Planning Commission Meeting
Tuesday, March 25, 2025 @ 5:30 PM

C. Pagosa West Sketch Major Subdivision Application

Pagosa West Sketch Major Subdivision Application
Planning Division Staff Brief

PAGOSA WEST
PAGOSA SPRINGS, CO
CONCEPTUAL MASTER PLAN / CS-10.1
PROJECT # 24-024.0
DATE: 02.04.2025
COPYRIGHT PINNACLE DESIGN, INC. 2025

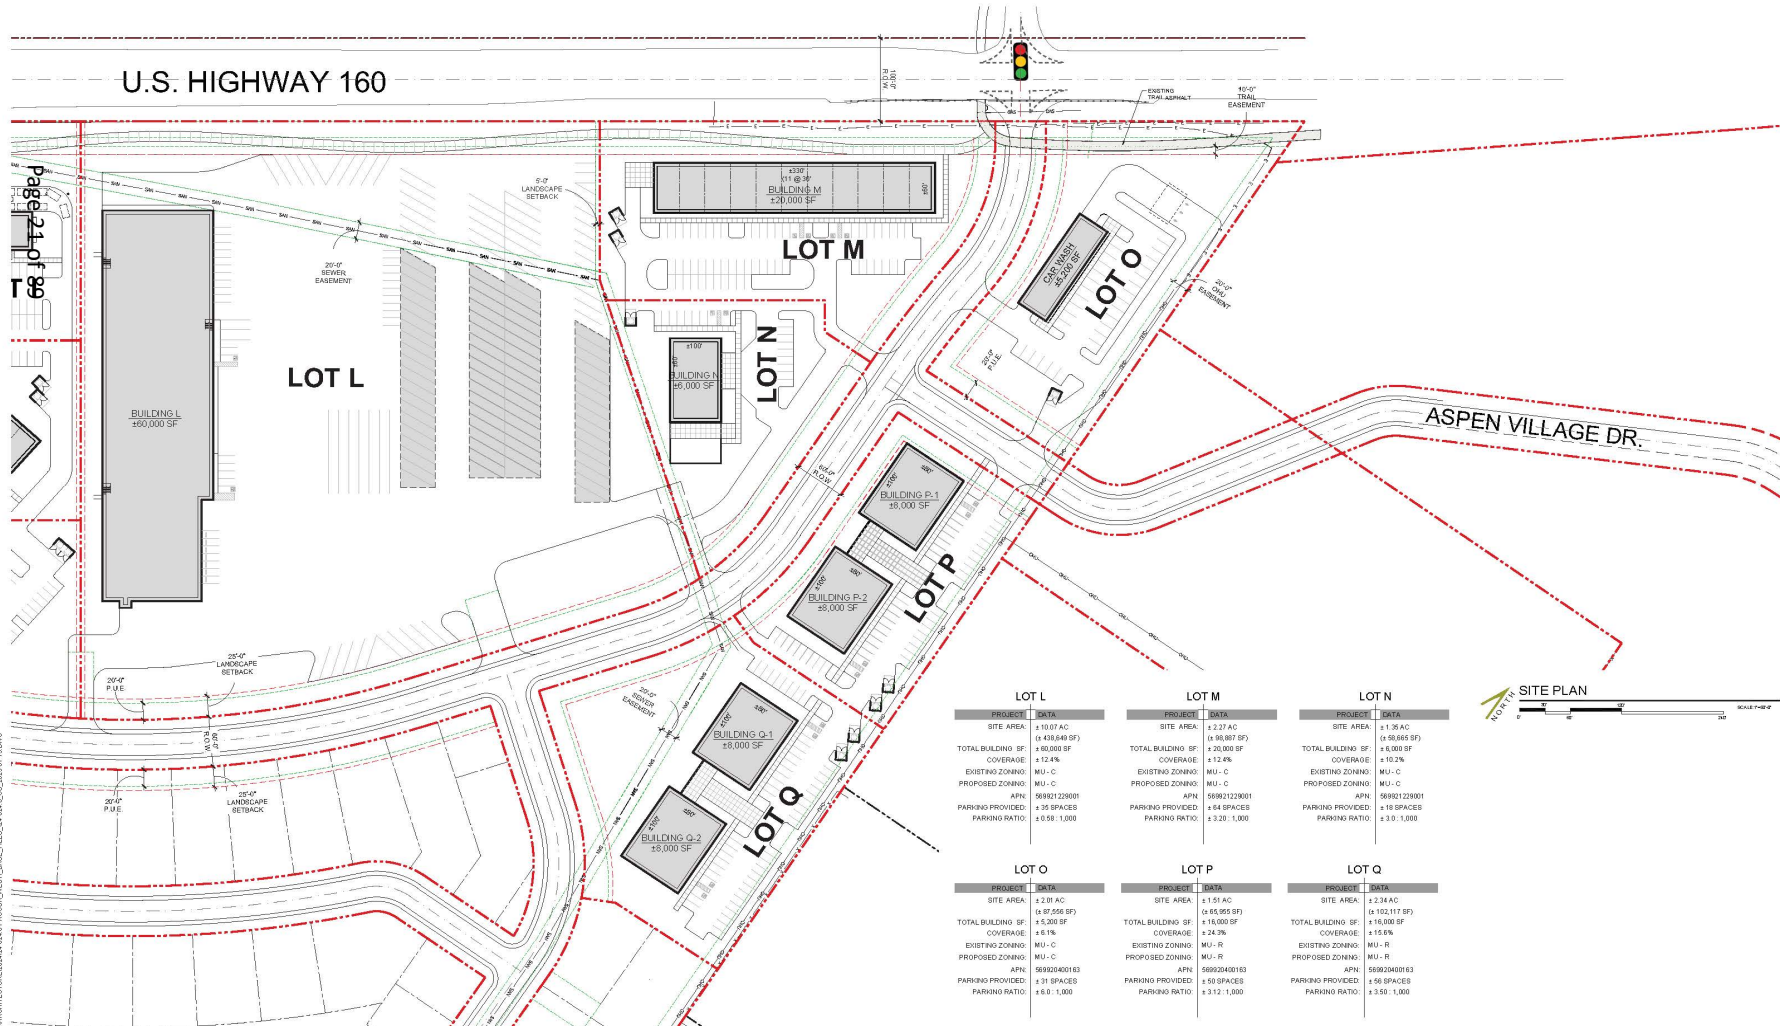
The applicant has provided a conceptual drainage plan. A drainage study will be required for submittal with the preliminary subdivision application, with runoff rates determined using the NRCS TR-20 method. The subdivision can only convey the current historic drainage from the property to

historic drainages, currently culverts under Hwy 160. There are areas indicated on the concept plan for potential detention ponds that would accommodate drainage from roads, sidewalks, and trails. The applicant mentioned that each lot will contain individual storm water detention facilities to serve each lot. Staff recommends that all existing drainage culverts under Hwy 160 be accessed, and a culvert condition analysis provided to the point of daylighting.

Sidewalks detached from roadways creating a landscape strip for snow storage have been requested by the Town, however, the current plan does not indicate such has been provided. Each individual lot shall provide snow storage areas within their respective Major Design Review application processes.

The Fire District has received the sketch plan and has asked to ensure fire hydrants are incorporated throughout the development. Additional reviews are required as the project matures. Typically, hydrants should be no further than 400-500 feet apart pending site-specific considerations.

- i. The Sketch plan shows a fairly dense development. Space for on-site storm water detention facilities will need to be considered during Major Design Review application submittals.
- ii. LUDC Sections 6.7.3. General Standards, 6.7.4. Additional Standards: Properties with Hwy 160 frontage, and 6.7.5. Additional Standards: Mixed Use Town Center should be addressed for the Preliminary Subdivision application.
- iii. Mature trees proposed to be preserved should be indicated on the site plans.

- i. Open Spaces should be noted on the site plans.
- ii. A sample single-family home and dimensioned property layout should be provided at preliminary application to ensure the proposed residential lots will accommodate driveway / garage.

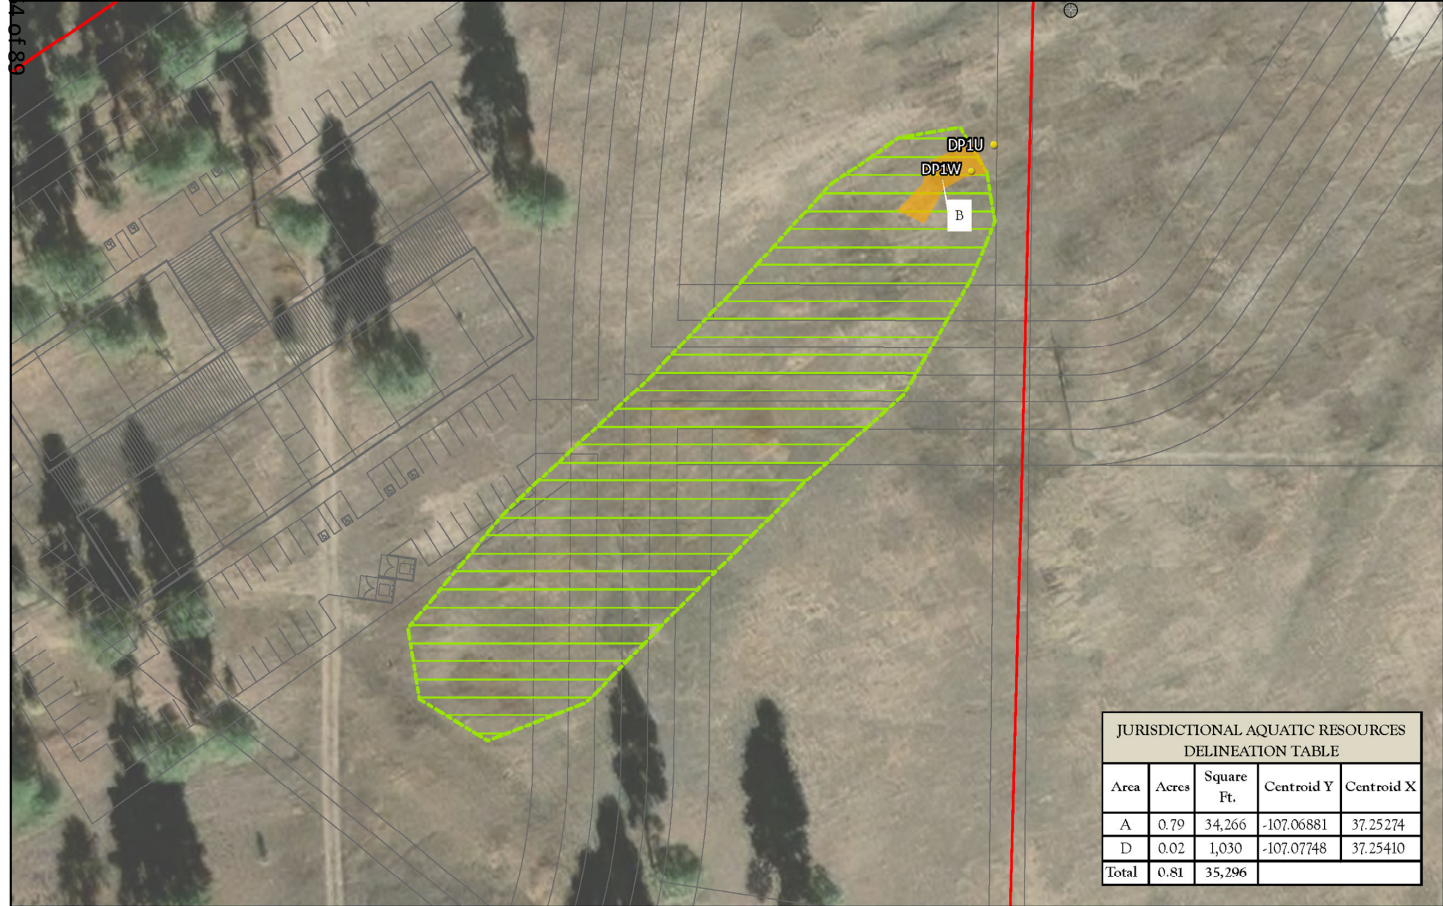
Their site map correctly identifies some areas as "wetlands". The primary Federal law protecting wetlands is the Clean Water Act(CWA). More specifically Section 404 which regulates the discharge of dredged or fill material into "waters of the U.S." The EPA's definition of "waters of the US" is very broad, encompassing different types of areas. I believe that definition and the application of wetlands protection under the Clean Water Act apply directly and specifically to the activities planned by the developer.

I believe our community deserves to see documentation that they will be in compliance with the Federal Clean Water Act regulation and Section 101(b)(3) of the National Environmental Policy Act. If they have not already submitted a comprehensive study of this area showing how they will be in compliance with the CWA and the NEPA; they should do so prior to any further actions being taken by them or the Town on their development. One of the many EPA requirements is to obtain a permit from the US Army Corps of Engineers to be allowed to fill in the wetlands where they plan to build houses, per their sketch.

Since both of the USACE-jurisdictional wetlands on the subject property will be avoided within the site plan and all other wetland areas on the property are non USACE-jurisdictional (in SME's opinion), there should be no need for a 404 Permit for the Pagosa Plaza project and a request for no 404 Permit required from the USACE is appropriate.
